APPLICATION NO.	FILING DATE	FIRST NAMED INVENTOR	ATTORNEY DOCKET NO.	CONFIRMATION NO.
10/501,812	07/19/2004	Werner Helms	016909-0320	4934
22428 7590 04/19/2007 FOLEY AND LARDNER LLP SUITE 500 3000 K STREET NW WASHINGTON, DC 20007			EXAMINER HARMON, CHRISTOPHER R	
			ART UNIT 3721	PAPER NUMBER
SHORTENED STATUTORY PERIOD OF RESPONSE		MAIL DATE	DELIVERY MODE	
3 MONTHS		04/19/2007	PAPER

Office Action Summary	Application No. 10/501,812	Applicant(s) HELMS ET AL.	
	Examiner Christopher R. Harmon	Art Unit 3721

DETAILED ACTION

Fig. 4

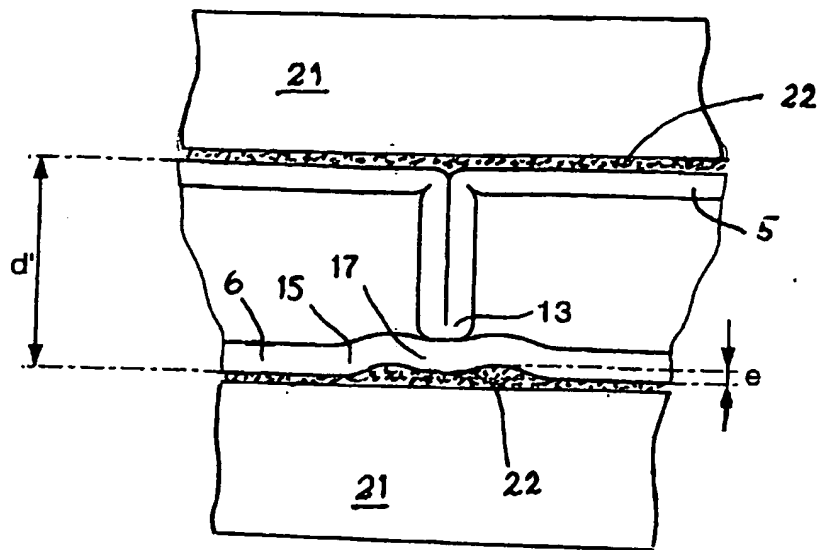
Regarding claim 23, figure 4 of Jean Louis depicts a heat exchanger assembly comprising heat exchange fins 40 and flat multi-chambered tubes of figure 1. It is uncertain whether or not the tubes and fins are braze-connected or corrugated, however because brazing corrugated fins is admitted as well known in the art as a form of connecting, (spec. page 6, lines 7+) it would have been obvious to one of ordinary skill in the art to braze the elements (corrugated or otherwise) together for the final assembly completion.
